December 19, 2018

**RE: Family Dollar  
1400 Gibson Blvd SE  
Request for Certificate of Occupancy - Temporary  
Hydrology Inspection - Approved  
Grading Plan Stamp Date: 5/11/18  
Certification Dated: 11/19/18  
Hydrology File: L15D049**

## FAMILY DOLLAR STORE GRADING &amp; DRAINAGE PLAN

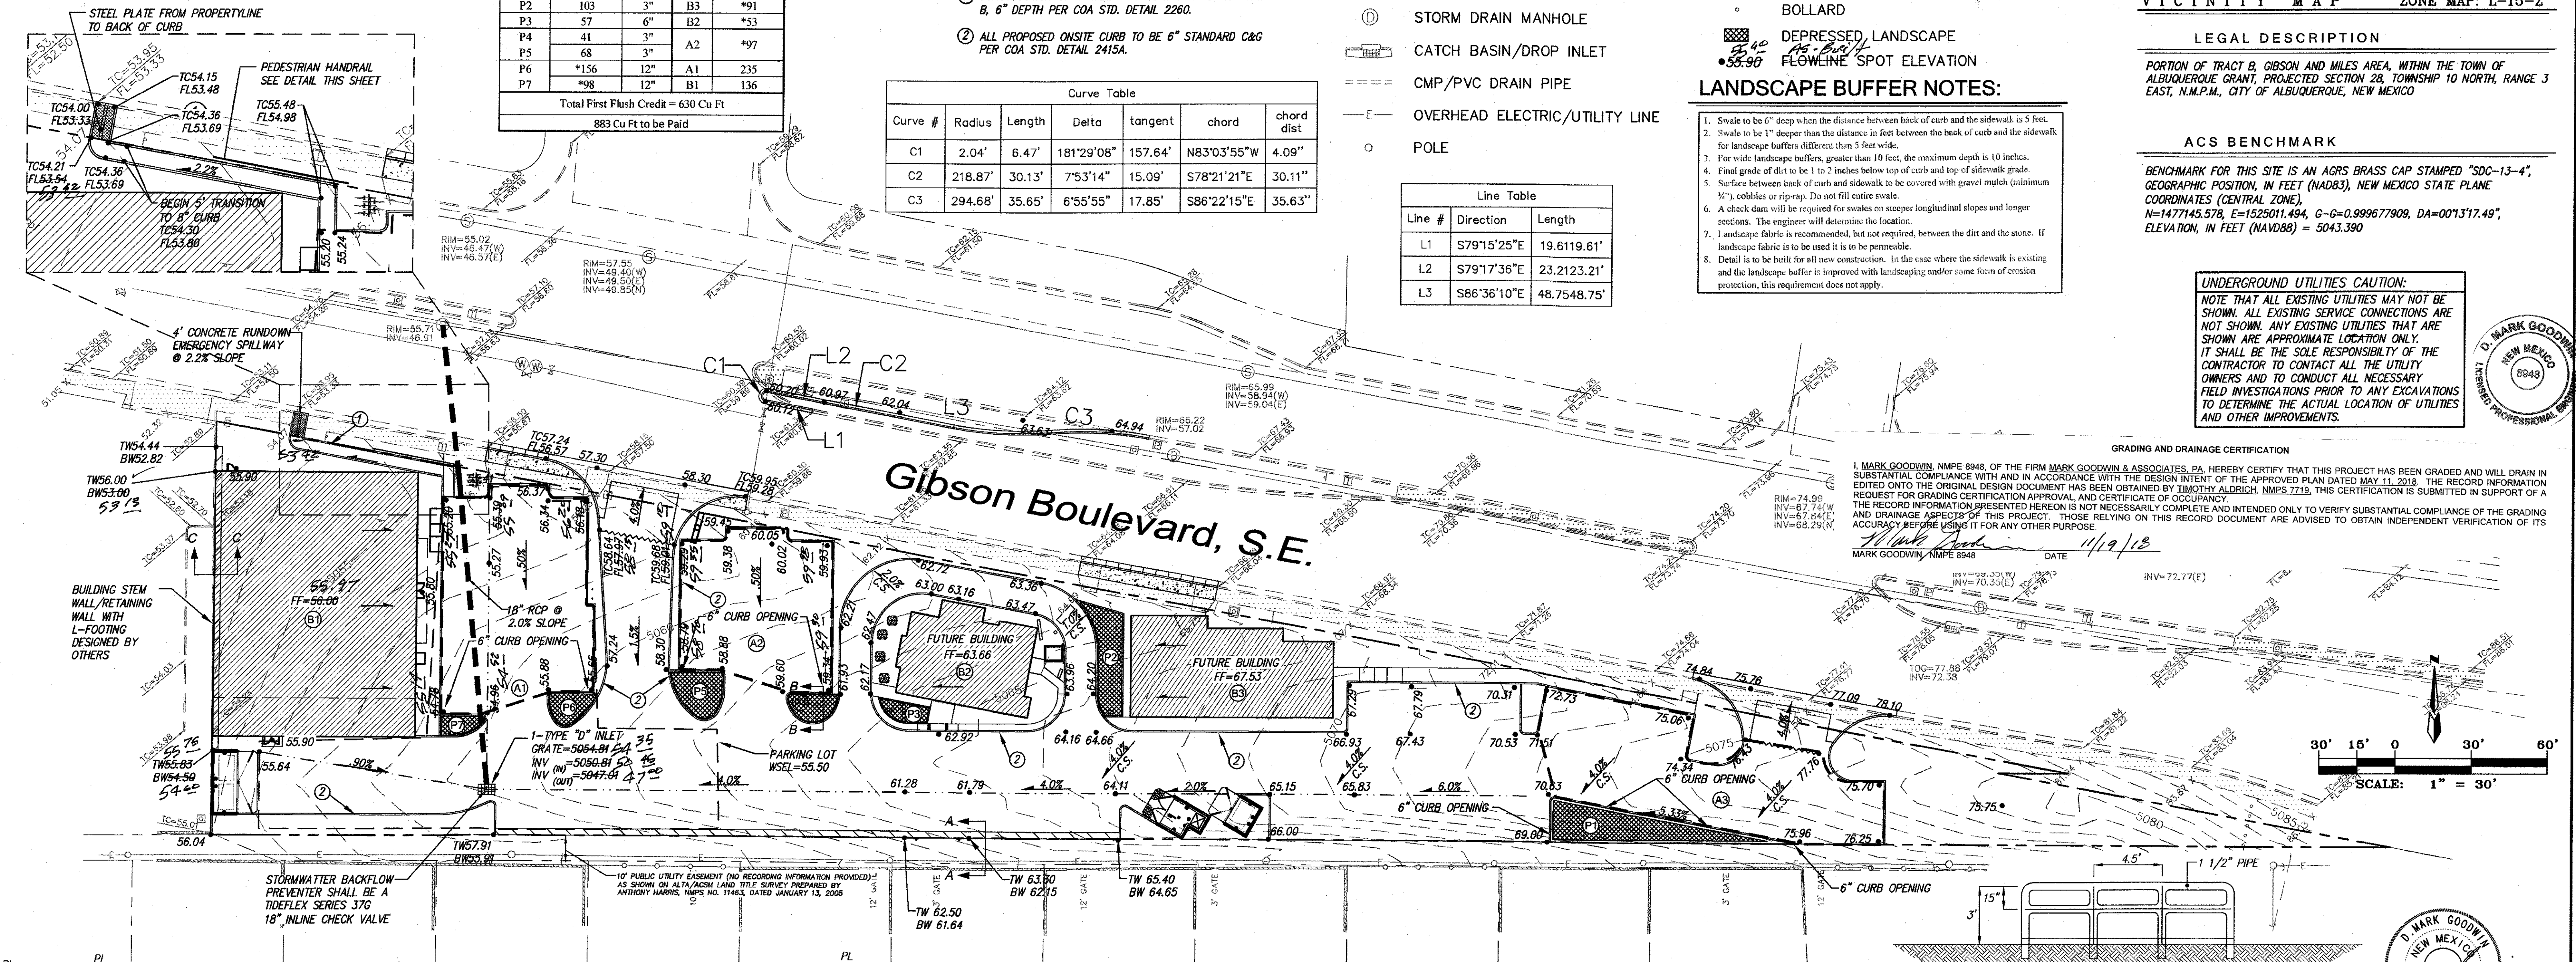
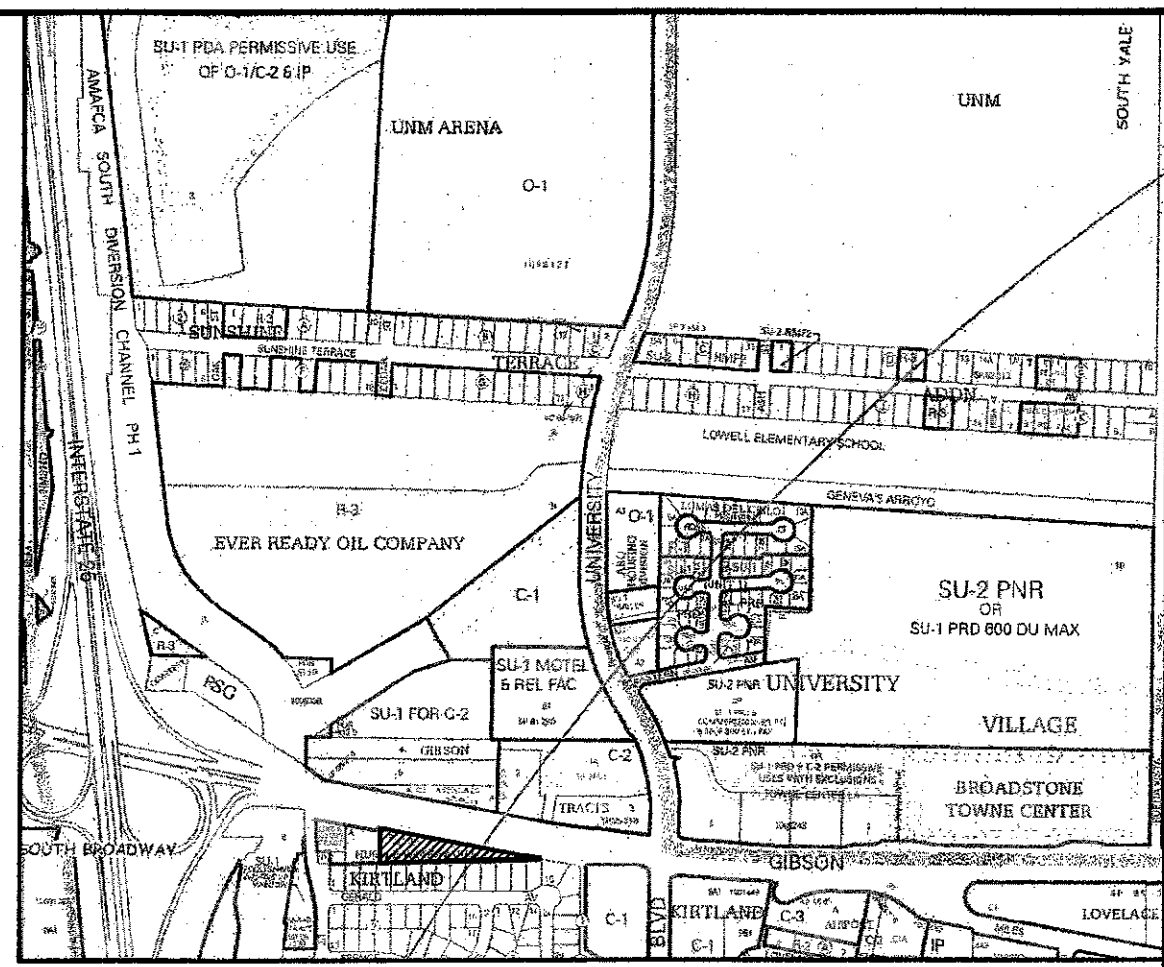
Based on the submittal received on 11/19/18, this certification is approved in support of Temporary Certificate of Occupancy by Hydrology.

Prior to Permanent Certificate of Occupancy:

1. The Public Work Order needs to be closed out and accepted by the City.
2. The backflow preventer needs to be installed and a new Engineer's Certification prepared to certify this installation.
